Village of Arlington Heights

May 1, 2018

RE: Proposed Mixed Use Development, Block 425

BLOCK 425 - MAP 6.7

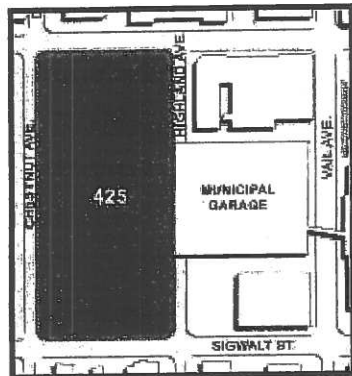
1. The Downtown Master Plan that was adopted in 2007 calls for the block to be developed in a cohesive manner with the northern three-quarters of the block designated with a height limit of 6-8 stories and the southern quarter of the block being 4-6 stories in height (see attached plan extract). While the Chestnut and Campbell buildings are consistent with this plan, the proposed building along Highland Avenue is inconsistent with the Downtown Master Plan. This building will need to be carefully analyzed in order to determine if its height is suitable for this block. The complete Downtown Master Plan can be viewed at www.vah.com.
2. Please provide an analysis on outlining which height bonuses were used to obtain the proposed 137'-6" building height for the Highland building in order to determine compliance with the B-5 density bonus requirements.
